To: Planning Board
FROM: Karl Guiler, Case Manager
DATE: October 21, 2016
SUBJECT: **Call-Up Item:** SITE REVIEW AMENDMENT: To amend the approved plans for Block 3 within the Dakota Ridge Village Subdivision for a 2,513 square foot community center with a community pool and 16 condominium units in two buildings. A similar proposal was approved in 2007 but the approval has since expired. Case no. LUR2015-00113. This approval is subject to potential call-up on or before **November 4, 2016**.

PROJECT NAME: **DAKOTA RIDGE VILLAGE BLOCK 3**

DESCRIPTION: **SITE REVIEW AMENDMENT to amend the approved plans for Block 3 within the Dakota Ridge Village Subdivision to develop a 2,513 square foot community center with a community pool and 16 condominium units in two buildings.**

APPLICATION: **Site Review, LUR2015-00113**

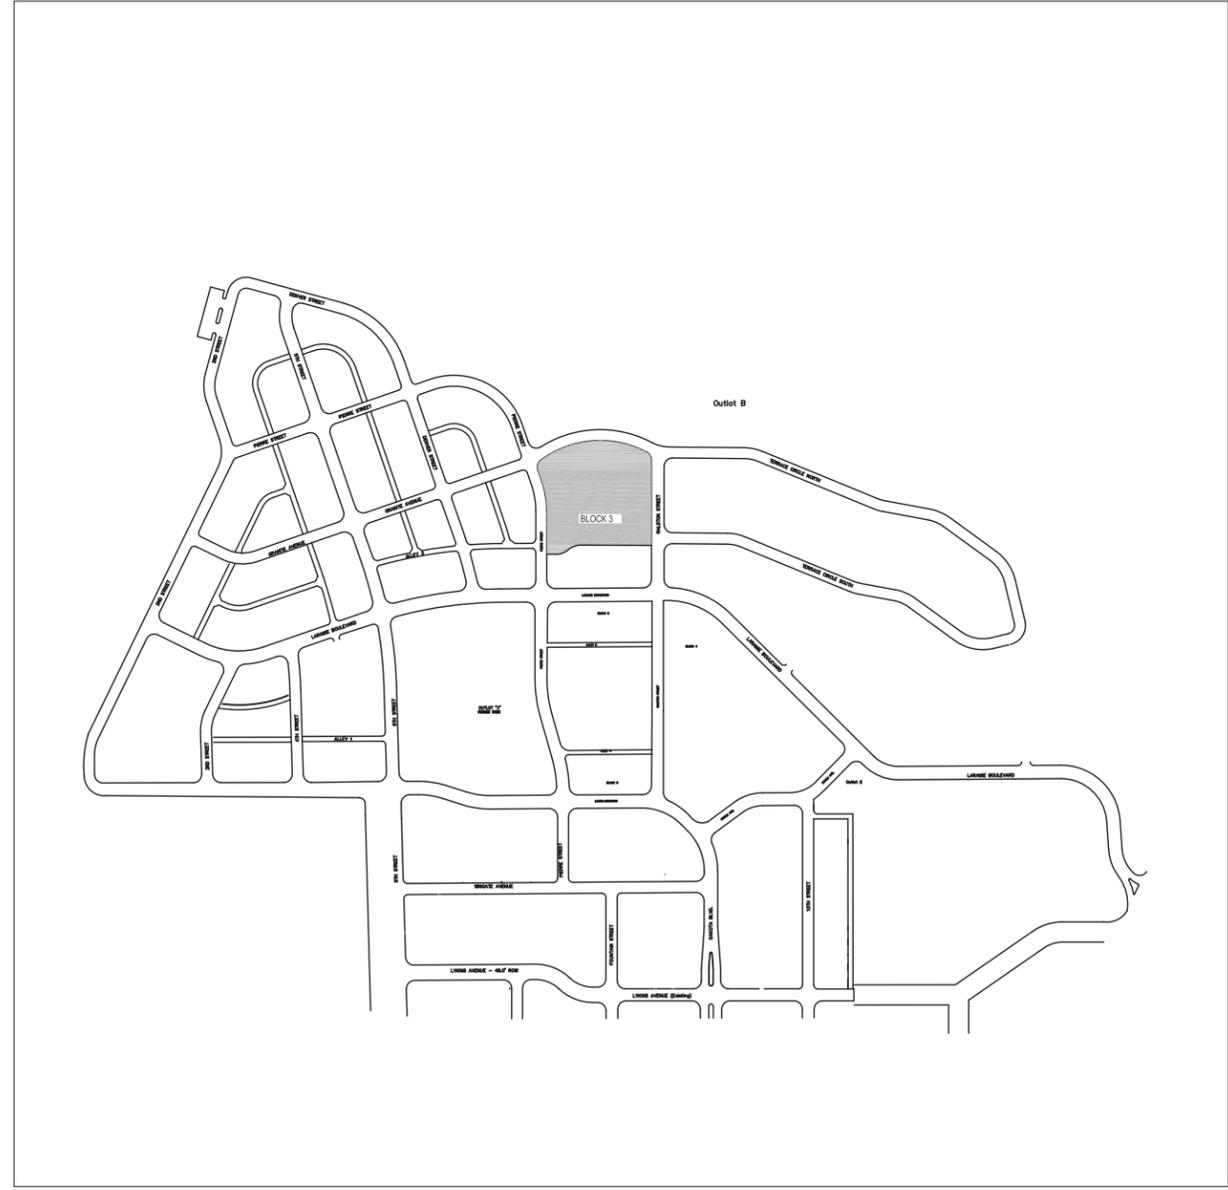
- b. A **final site plan** which includes detailed floor plans and section drawings. The site plan and associated civil drawings shall include a shift in the location of the surface parking lot roughly 3 feet to the east in order to meet the 20-foot landscape setback for parking areas.
